MODEL 1900

SUBJECT: To Tighten Driver Lever Mounting Stud.

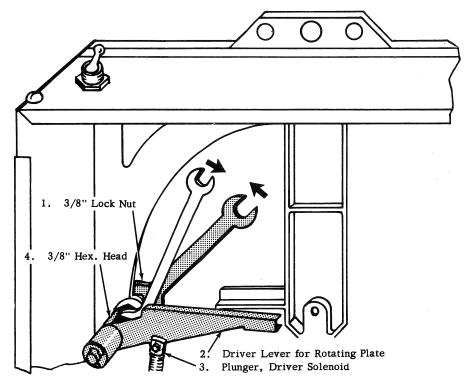
1. In cases where a wrong letter selection is experienced it may be found that the "Mounting Stud" for the "Driver Lever of the Rotating Plate" has loosened. As shown in sketch below, this stud may be tightened from underneath the selector by using one 3/8 open end wrench to tighten and hold the stud and a second 3/8" open end wrench to tighten the lock nut.
